Subject: Environmental Impact Statement - EnergyConnect (NSW Eastern Section) (SSI 9172452)

ATTACHMENT A – BCD Assessment Summary for Flooding – EnergyConnect (NSW Eastern Section) Environmental Impact Statement (SSI 9172452)

ATTACHMENT D – Detailed comments for Biodiversity – EnergyConnect (NSW Eastern Section) Environmental Impact Statement (SSI 9172452)

Figure 1 Proposed laydown site adjacent to the Cobb Highway. Native vegetation mapping on the proposed laydown site that is not included in vegetation zones.

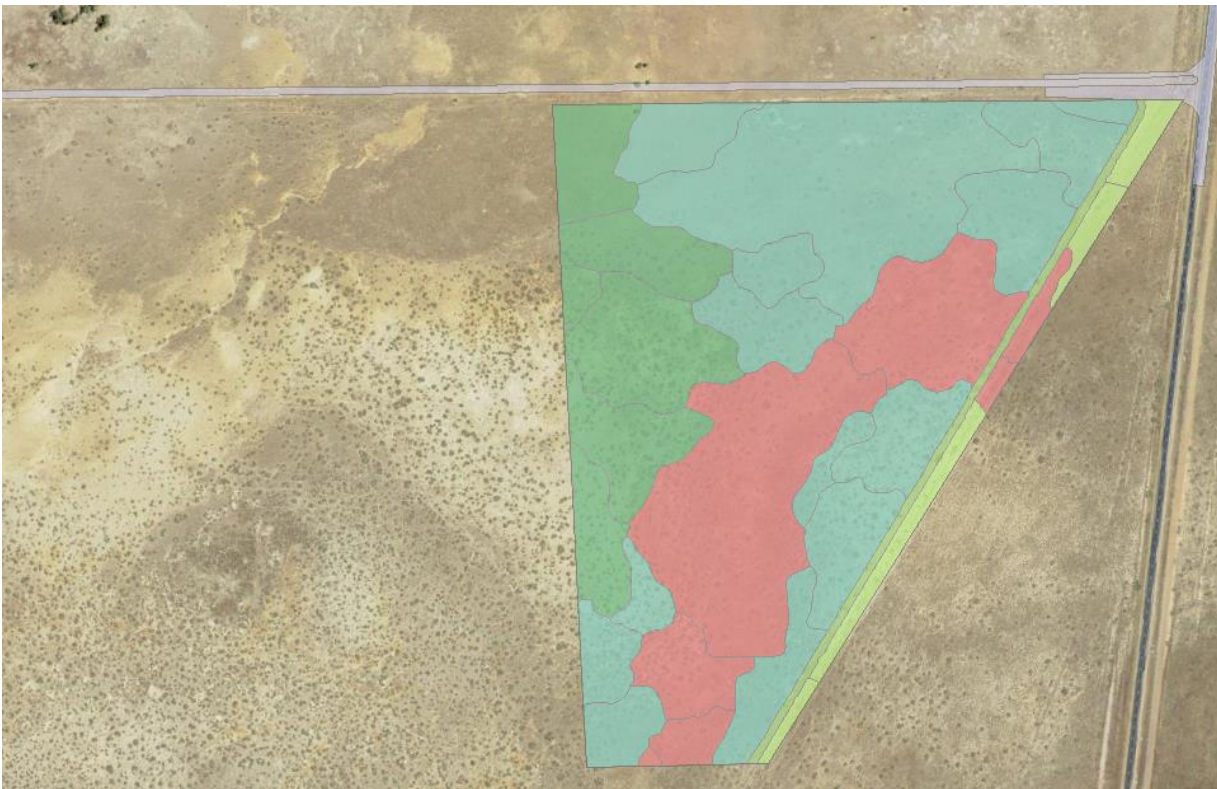
For example, the proposed laydown site adjacent to the Cobb Highway does not include impacted vegetation zones. Despite this, a 10-metre wide access road will cut through 6.5 kilometres of native vegetation to the laydown site from the proposed easement (see Figure 1 below).

- 5.1 Update vegetation zone mapping to include native vegetation associated with all ancillary facilities including, but not limited to, new access tracks to laydown sites and accommodation camps.
- 5.2 Update the scattered tree assessment to capture all scattered trees for the Urana-Lockhart Road accommodation camp, and any other ancillary facilities with scattered trees where they are currently not assessed.
